MEMORANDUM

Subject: VAR18-0002 – Variance request to Section 5-313 of the Subdivision Ordinance to request a reduction in roadway width from 30 feet to allow a 28 foot roadway from face-of-curb to face-of-curb, with parking on one side in an RR-1 zoning district for the proposed Kinloch Subdivision at 2600 North Main Street. Submitted by Balzer and Associates for Lucas Construction and Development, Inc. (owner).

MEMORANDUM

SUBJECT: Kinloch Subdivision Variance Request

A diagram showing the applicant's proposed 28-foot face-of-curb to face-of-curb with parking on one side, roadway section is shown below:

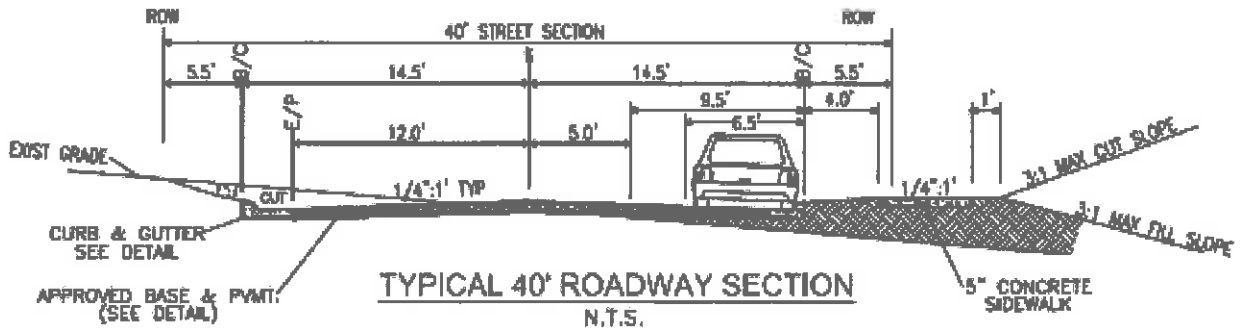
The applicant's diagram only shows a 6.5 foot width for the parked vehicle from the back of curb with parking in the 2-foot gutter pan. A parallel parking space in the town is 8 feet wide, the opposing gutter pan is 2 foot wide, and the curbs are 6 inches wide. With parking on one side, the applicant's submitted roadway section has a two-way travelway of 18 feet, which then only allows 9 feet for each of the traffic lanes.

1. The Town standard parallel parking space is 8 feet wide. A public street cross section of 28 feet wide from face of curb to face of curb, minus the 8 feet parking width and 2 foot opposing gutter pan, leaves a street width of 18 feet (or two, 9-foot-wide travel lanes) for traffic to travel. We believe this section is too narrow for two vehicles to safely pass by each other.

4. For safety reasons, Town Staff feels that if a developer of a new subdivision desires to allow parking on one side of the new street, the Town standard street width of 30 feet, face of curb to face of curb, shall be required.

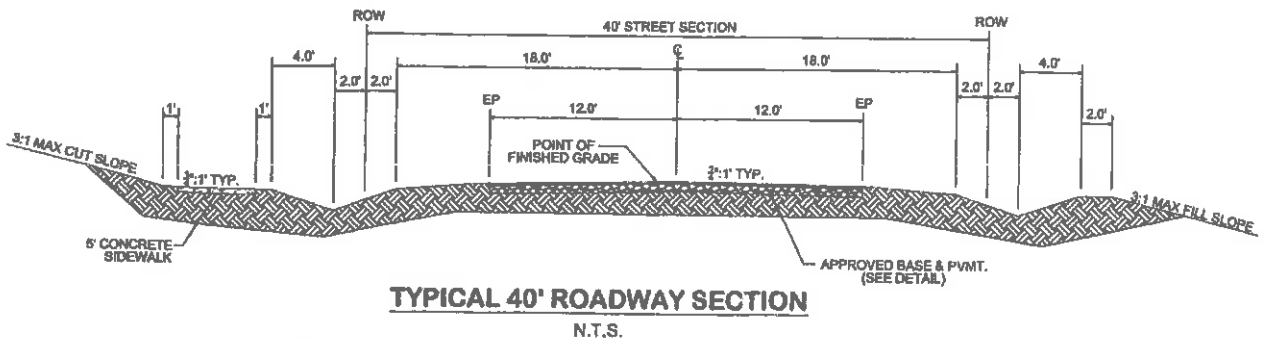
The Town of Blacksburg's Standard 30-foot face-of-curb to face-of-curb with parking on one side, roadway section has a two-way travelway of 20 feet, which is 2 more feet of actual street width to allow for safer passing of vehicles with 10 feet for each of the traffic lanes (see memo from the Town Engineers, Attachment A). The Engineering staff have concerns about the reduced width.
